**Agenda**  
**City of Springboro Planning Commission Meeting**  
**Wednesday, August 18, 2021, 6:00 p.m.**  
**Council Chambers, Springboro City Building, 320 West Central Avenue**

**Background Information & Staff Comments**  
**City of Springboro Planning Commission Meeting**  
**Wednesday, August 18, 2021, 6:00 p.m.**

**Site Plan Review, 465 Victory Drive, new commercial building for B&E Plumbing**

**Site Plan Review, 95 West Central Avenue (SR 73), proposed vehicle service facility for Foreign Exchange**

## PLAN VIEW - DUMPSTER ENCLOSURE

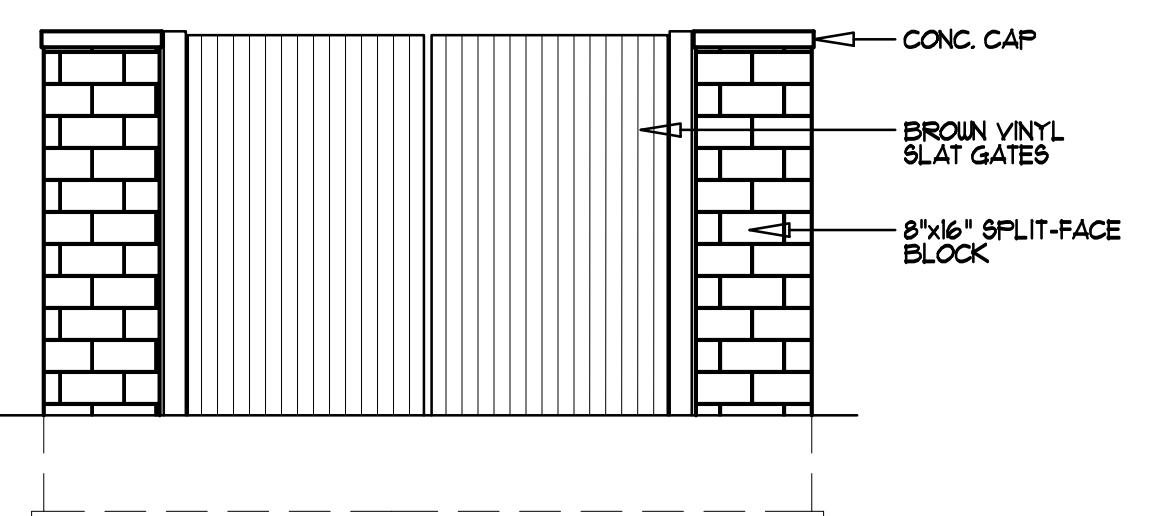
1. Provide materials board or samples prior to or at August 18th Planning Commission meeting.
2. For proposed dumpster screening and gate, provide exterior materials sample or board including color. Also, verify the dumpster pad size as it does not correspond with the dumpster enclosure detail.

Sheet No.: C-2.0

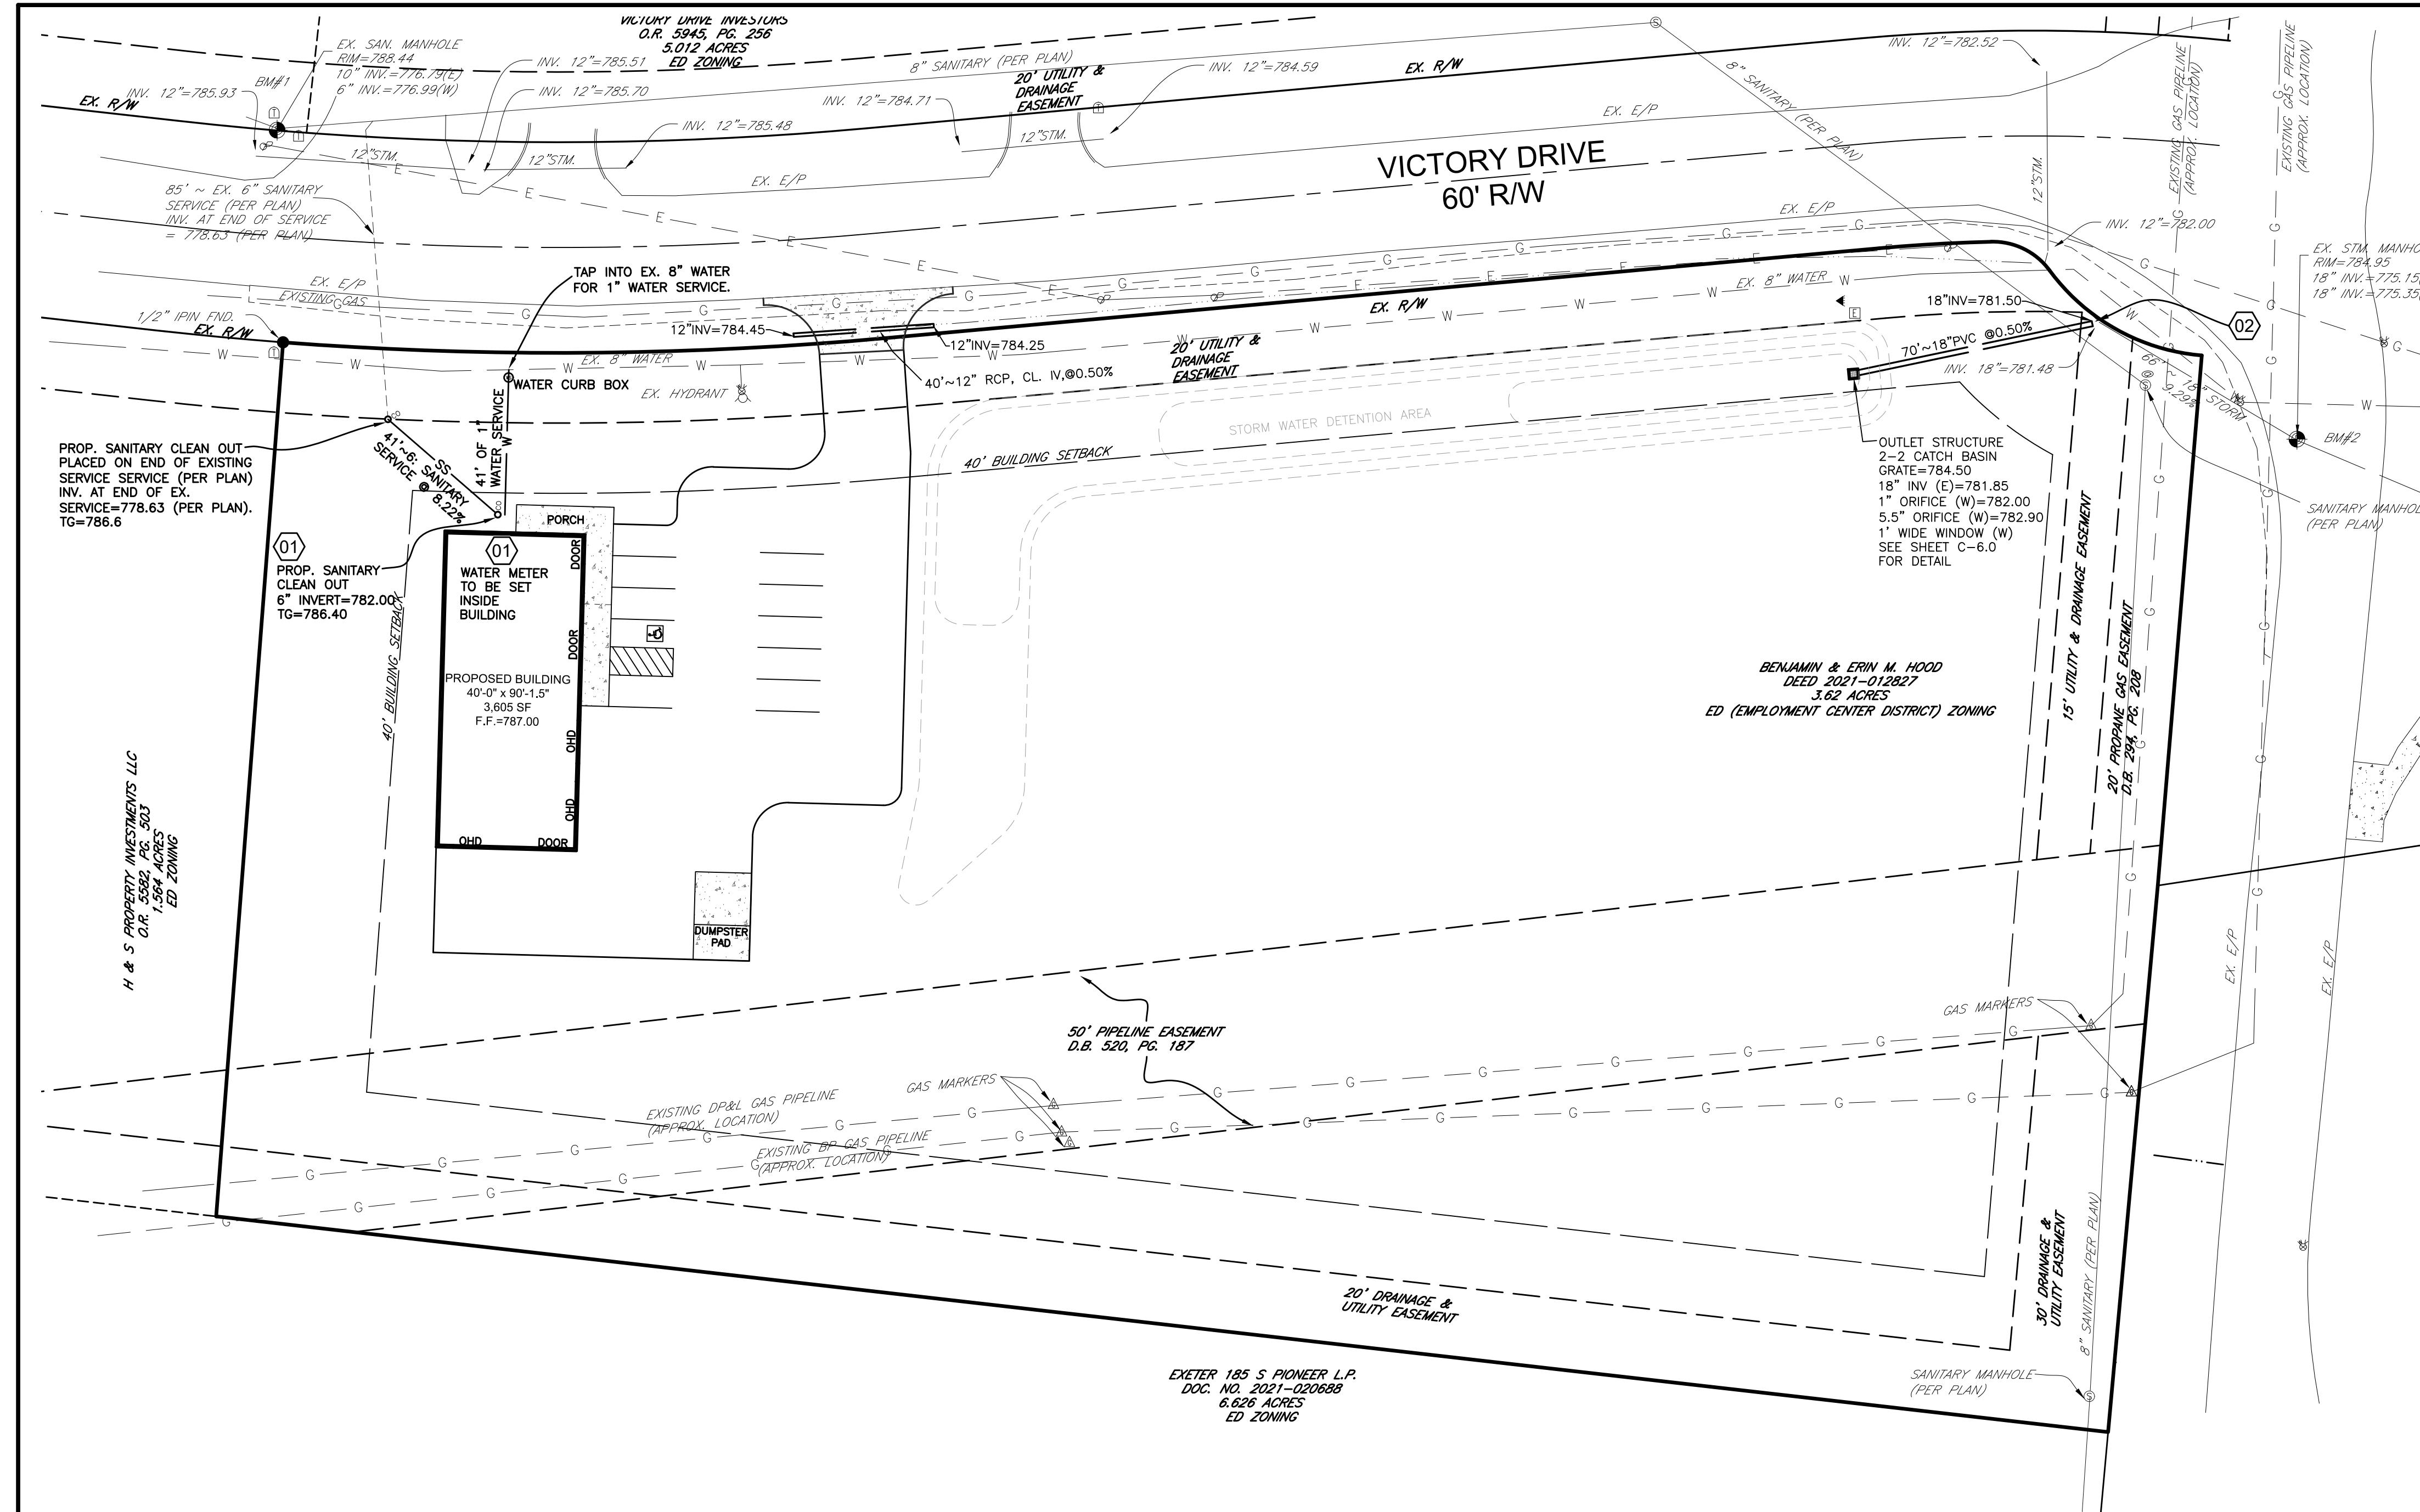
1. Setbacks are established for sites located in ED, Employment Center District, during site plan review process. Applicant to label site plan accordingly following preliminary review.

3. For the landscaping plan the following comments apply:
  - a. Provide a schedule of proposed landscaping including number of trees proposed, scientific and common names, and size (measured as DBH), 2.5 inches minimum for shade trees, 2 inches for ornamental trees, 6 feet in height for evergreen trees.

- c. Provide 1 additional shade tree on Victory Drive frontage (4 required, 3 provided), 3 additional trees on south property line buffer (5 required, 2 provided), Less credit indicated in b. above, provide 6

### ELECTRICAL SITE PLAN - PHOTOMETRICS

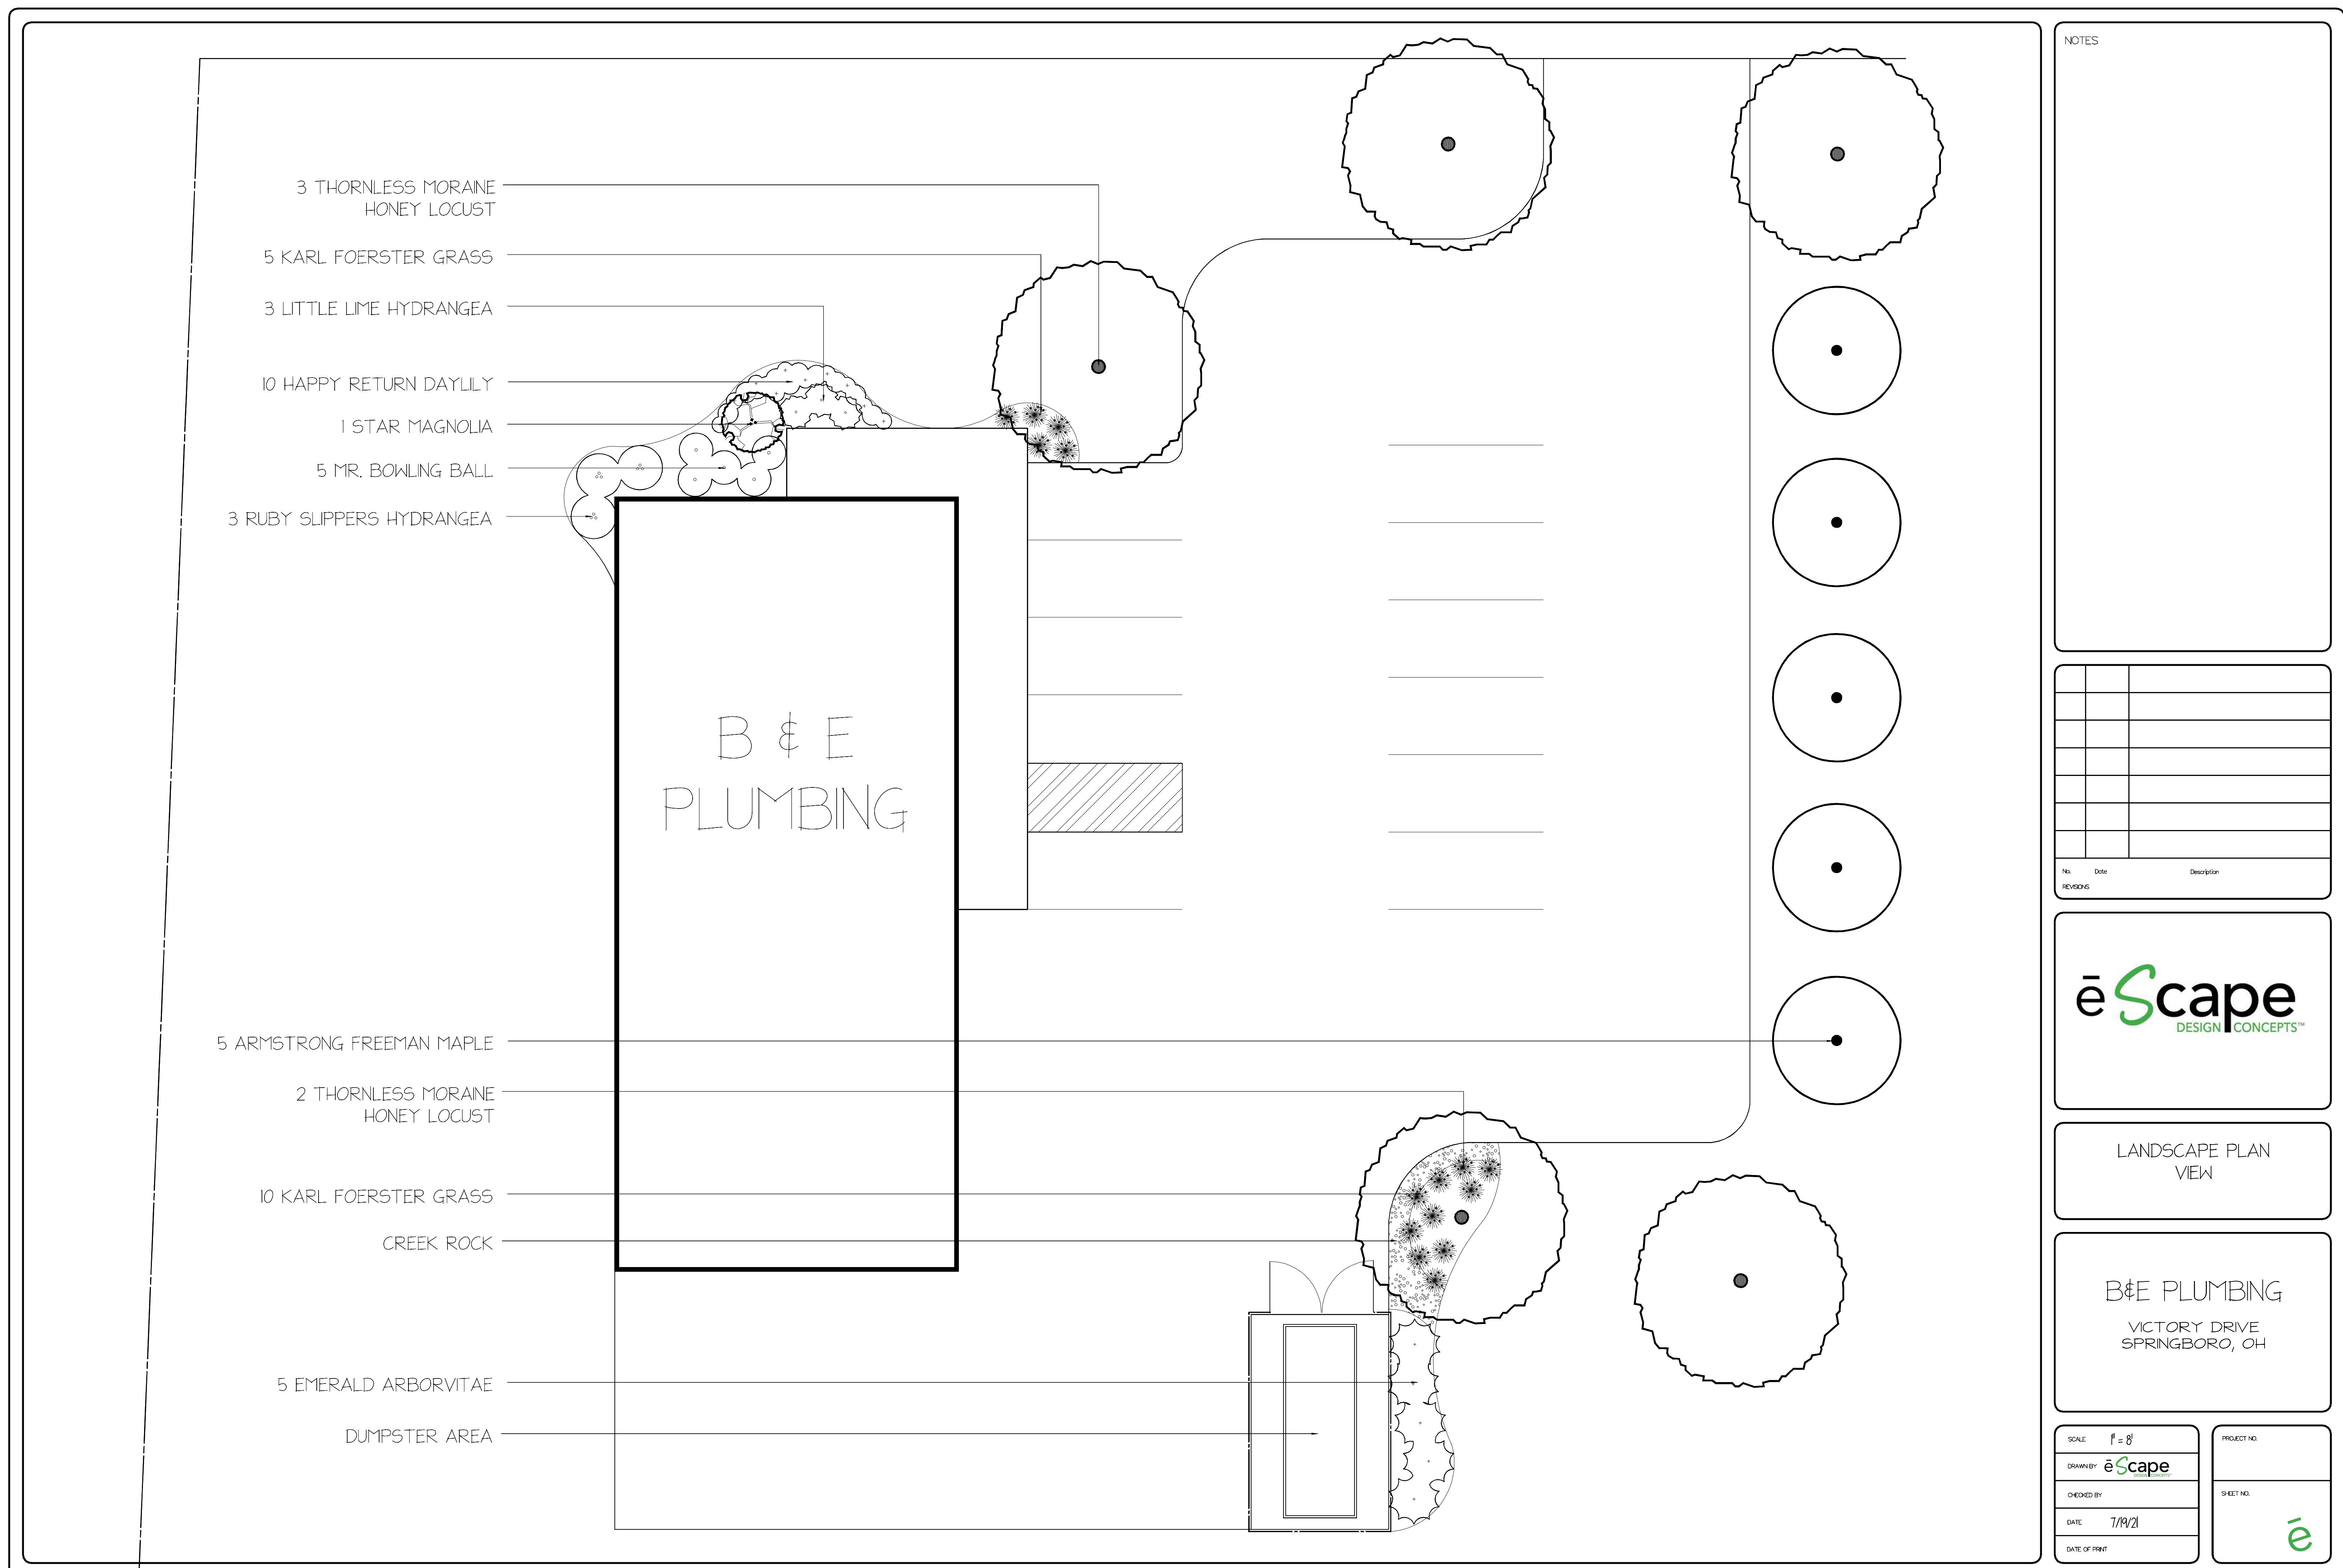
4. Lighting plan to be provided for site plan consistent with Chapter 1273 of Planning and Zoning Code to staff prior to August 18th meeting. Plan to include photometric analysis, specs for proposed lighting fixtures for site and building, and indication of compliance with color-temperature of lighting (not to exceed 3500° Kelvin) among other design requirements.
